\*\*\* SUBCASE 20080507-0244-1 CREATED 05/09/2008 04:39:21 PM hansenwi

**Dave Spence - Unit 2 LSB Erosion Analysis**

IPP, Unit 2 LSB Erosion (270T151)

**SUBJECT: Inspection of Intermountain 2 Last Stage Buckets**

LP C TE L-0 1

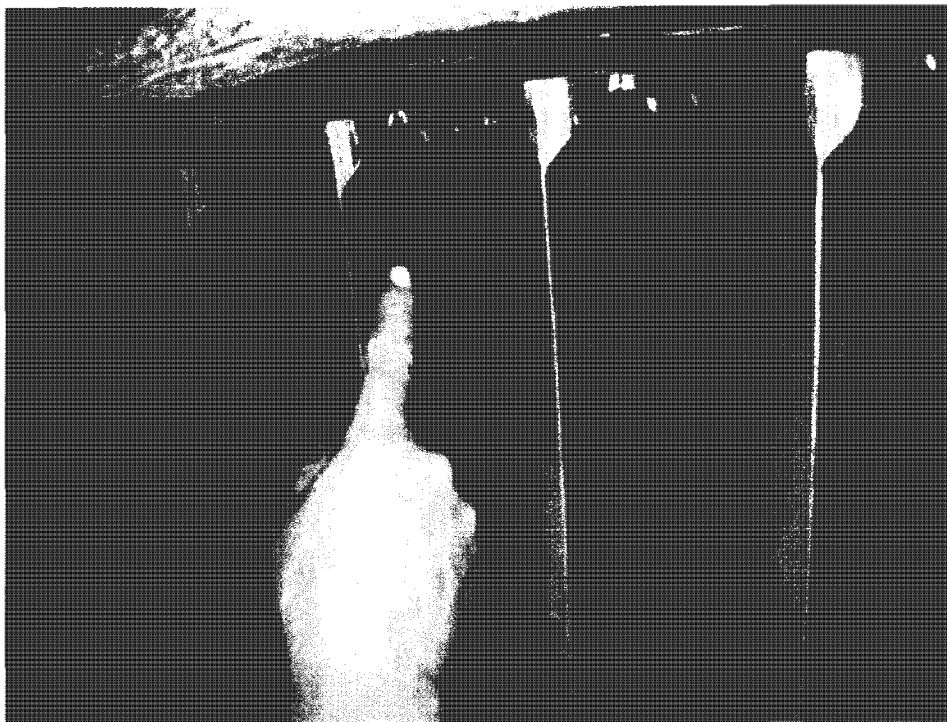
The L-0's on LP A, B, and C were visual and NDE examined per TIL-1521 and GEK46354. As noted in past IPP QC records there is erosion on Inlet Side of all L-0 Buckets.

PRO comments are profile doesn't cause to much short term concern but should be replaced at next major outage.

Monitor LP L-0's per TIL-1521 and GEK46354 and replace on next major outage.

Figure 1-TA Last Stage Buckets

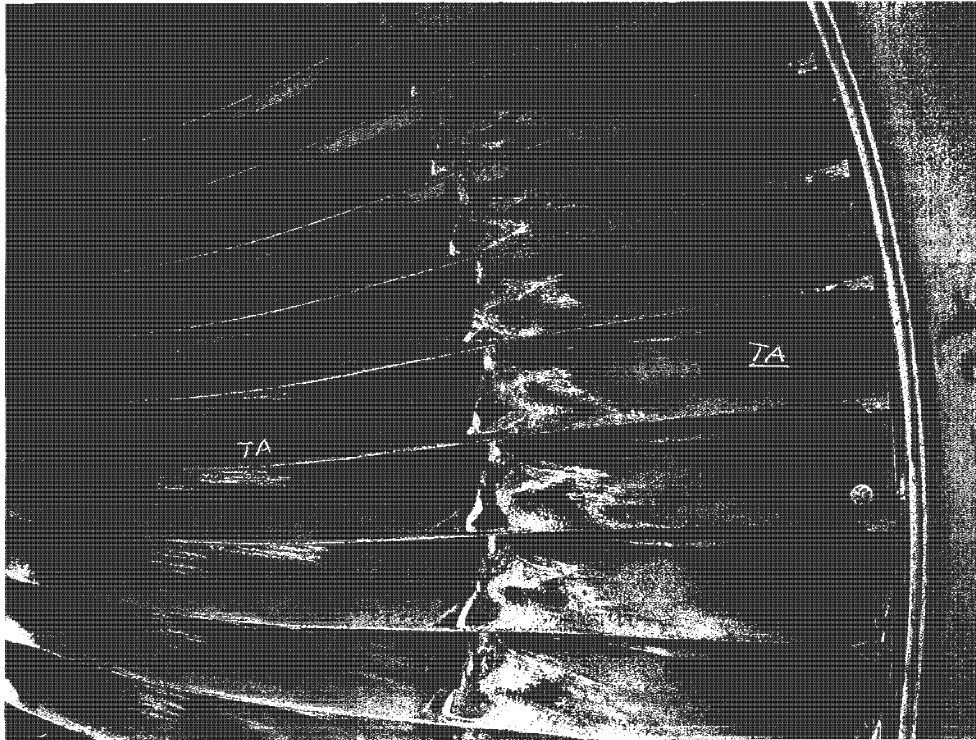
<b>INTERMOUNTAIN POWER - 30" LAST STAGE BUCKETS – APRIL 2008</b>	
TA	<ul style="list-style-type: none"> <li>-Trailing edge erosion heaviest of the 6 ends, with erosion up to near the tie wire on many, but no notches in trailing edge.</li> <li>-Discharge side tenon erosion similar to 20GA and much less than 20TB, with minimum wall thickness <math>\approx .060</math>".</li> <li>-Erosion on admission side of cover is moderate and similar to other rows.</li> <li>-Admission edge has erosion back from leading edge as on other turbine end rows, but erosion less than TB and TC, with erosion back <math>1/8</math>".</li> </ul>
GA	<ul style="list-style-type: none"> <li>-Trailing edge erosion similar to "B", with heavy erosion on some and none on others, but even on buckets with heavy erosion, the erosion has not produced notches in the trailing edge.</li> <li>-Discharge side tenon erosion &lt;"B", with thickness in eroded areas at base on inside <math>\approx .065</math>"-.070".</li> <li>-Admission side of cover has moderate erosion similar to "B" and "C".</li> <li>-Admission vane tip has slight erosion back from leading edge (up to <math>1/8</math>"), with the heaviest erosion only going down a few inches (&lt;TB or TC). No significant notches in leading edge.</li> </ul>
